PLANNING COMMITTEE – 4 JUNE 2019

Application No: 19/00408/FUL

Proposal: Demolition and replacement of an existing dwelling and the

Location: Grange Farm

Sanderson's Map of 1836 on the left, compared to modern map on the right

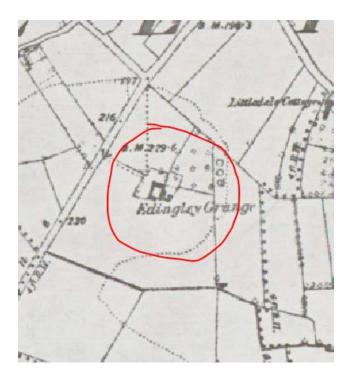
However, the house is a former farmhouse and in my estimation dates to the later Georgian/early Victorian era in age and style, being early to mid C19 in date. While the quality of the map is a little unclear there are buildings on the site in Sanderson's Map of 1836, but it is hard to be sure if these are the same buildings:

The buildings at this farm are clearly depicted on the historic map from 1875/85:
